**City of Ketchum
Planning & Building**

IN RE:)
)
The Perry Building) KETCHUM PLANNING AND ZONING COMMISSION
Design Review) FINDINGS OF FACT, CONCLUSIONS OF LAW, AND
Application File Number: P22-045C) DECISION
)
)
Date: March 28, 2023)

PROJECT: The Perry Building

APPLICATION TYPE: Design Review

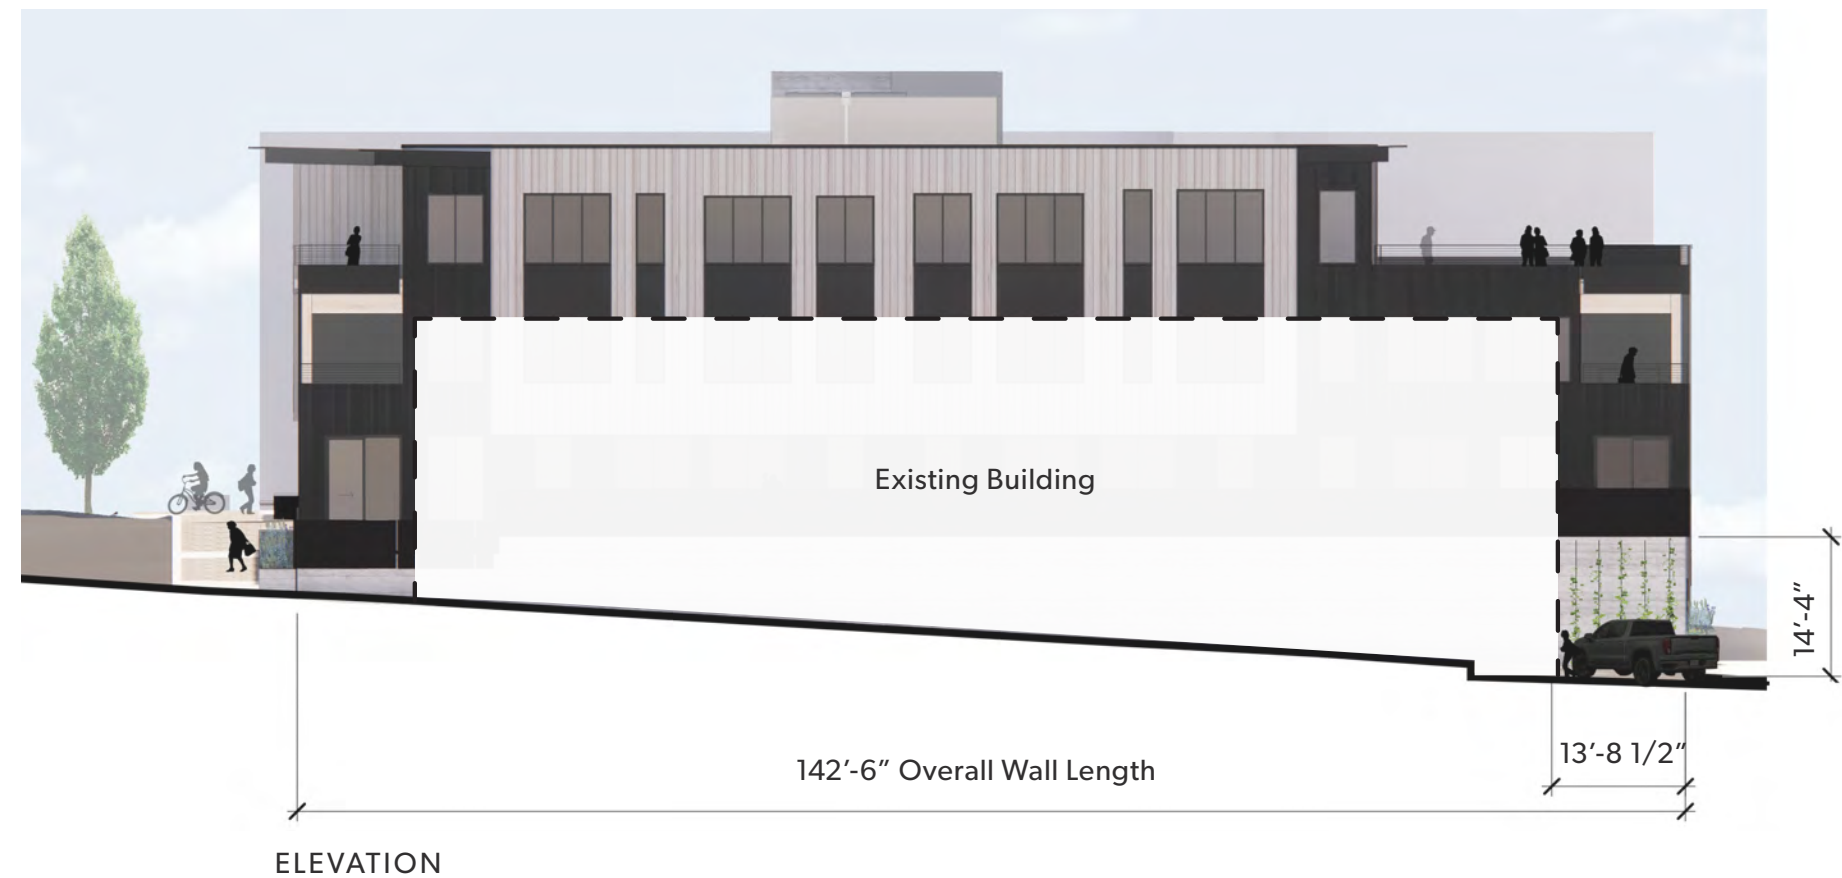
The exposed parking garage wall at the interior side façade is comprised of board-formed concrete with no window openings or exterior material differentiation. During their review of the Pre-Application, the Commission requested that the applicant provide an exhibit showing the interior side wall within the context of the adjacent Westside Office Condominiums. The exhibit provided on page 66 of the project plans shows that the West Side Office Condominiums building covers most of the parking garage wall leaving only 14 linear feet exposed (See Figure 5). The applicant has proposed installing Virginia Creeper vines to soften the exposed parking garage wall

The Commission requested that the applicant provide an exhibit that shows the design of the exposed portion of the west interior side elevation that outlines the adjacent Westside Office Condominium building.
